# Service Bulletin

Bulletin No.: 19-NA-015

**Subject: HVAC Temperature or Mode Control Inoperative**

Brand:	Model:	Model Year:		Breakpoint:		Engine:	Transmission:
		from	to	from	to		
Chevrolet	Trax	2017	2019	SOP	August 08, 2018	—	—
	Tracker	2018			August, 2018

2772058

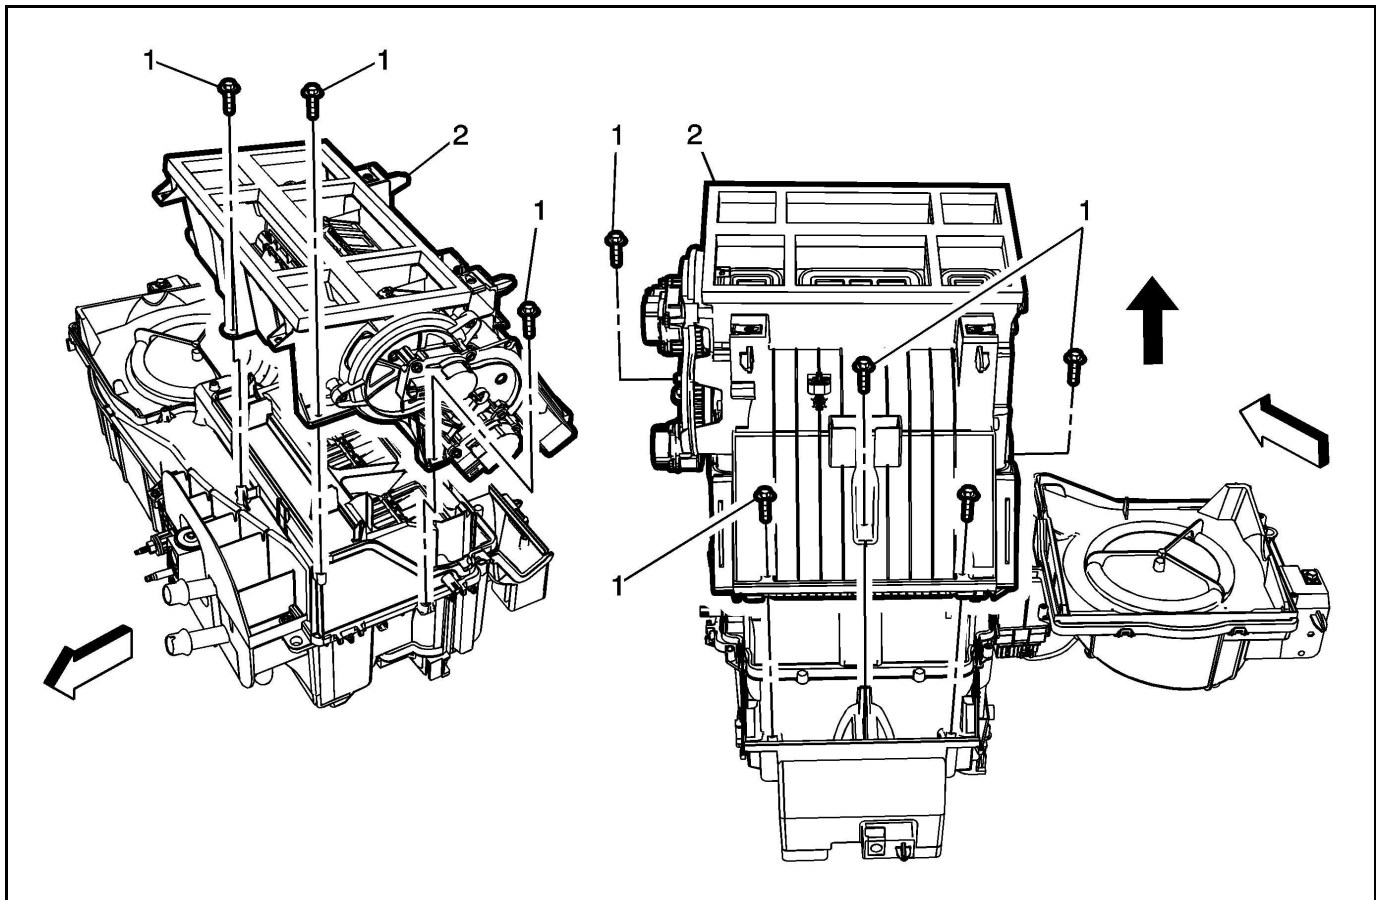
<b>Involved Region or Country</b>	North America, Brazil, Israel, Middle East, China, GM Korea Company, Malaysia, Uzbekistan
<b>Condition</b>	Some customers may comment on one or more of the following concerns: <ul style="list-style-type: none"> <li>• Temperature control inoperative</li> <li>• No heat</li> <li>• No defrost</li> <li>• Binding noise</li> </ul>
<b>Cause</b>	This condition may be caused by the air conditioning evaporator case not aligning with the upper HVAC housing case, causing the control gears not to engage properly when adjusting the temperature.
<b>Correction</b>	<ol style="list-style-type: none"> <li>1. Check the temperature and mode cables operation as instructed in Service Bulletin 17-NA-113 (Document ID# 4694428).</li> </ol> <p>⇒ If the gear mesh is lost during adjustment, replace the air conditioning evaporator case.</p> <ol style="list-style-type: none"> <li>2. With the cable detached, verify that the mode and/or temp doors move freely.</li> </ol> <p>⇒ If the doors are sticking with the cables detached, replace the air conditioning evaporator case.</p> <p><b>Note:</b> When replacing the case, a new cable retention feature has been added to prevent kinking of the cable.</p>

Refer to *Air Conditioning (A/C) Evaporator Case Assembly Replacement* in SI.
